United States Patent and Trademark Office

| APPLICATION NO. | FILING DATE | FIRST NAMED INVENTOR | ATTORNEY DOCKET NO. | CONFIRMATION NO. |
|----------------------------------|-----------------|----------------------|-------------------------|------------------|
| 09/740,053 | 12/20/2000 | Kiyonori Shiraki | NIT-244 | 5572 |

DETAILED ACTION

IG. 3 R ART

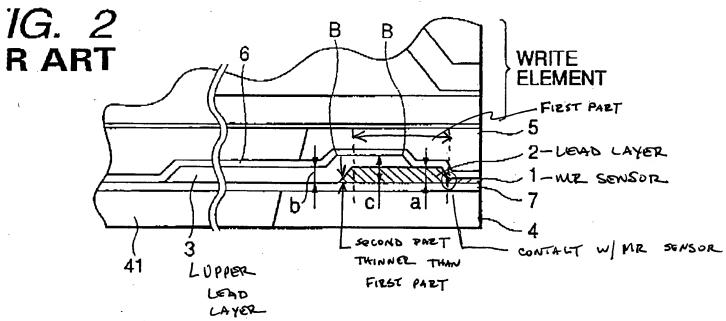
- 2. Claim 12 is rejected under 35 U.S.C. 102(b) as being anticipated by Applicant's Admitted Prior Art (hereinafter AAPA) (pg. 3, lines 4-15; Fig. 2).

- Regarding claim 12, AAPA shows an integrated thin film head, comprising:
 - a lower shield layer (4) formed on a substrate;
 - a lower readgap layer (7) formed on said lower shield layer (4);

- a MR sensor layer (1) formed on said lower readgap layer (7);
 - a lead layer (2) joined with said MR sensor layer (1);
 - an upper lead layer (3) formed partially in contact with said lead layer (2);

- an upper readgap layer (6) formed to cover said MR sensor layer (1), lead layer (2) and upper lead layer (3); and
 - an upper shield layer (5) formed on said upper readgap layer (6),

wherein said lead layer (2) includes a first part including a part in contact with said MR sensor (1) and a second part which is continuous with said first part and is thinner than said first part, and said portion of said upper lead layer (3) overlaps said second part of said lead layer (2) (see attached Figure 2).
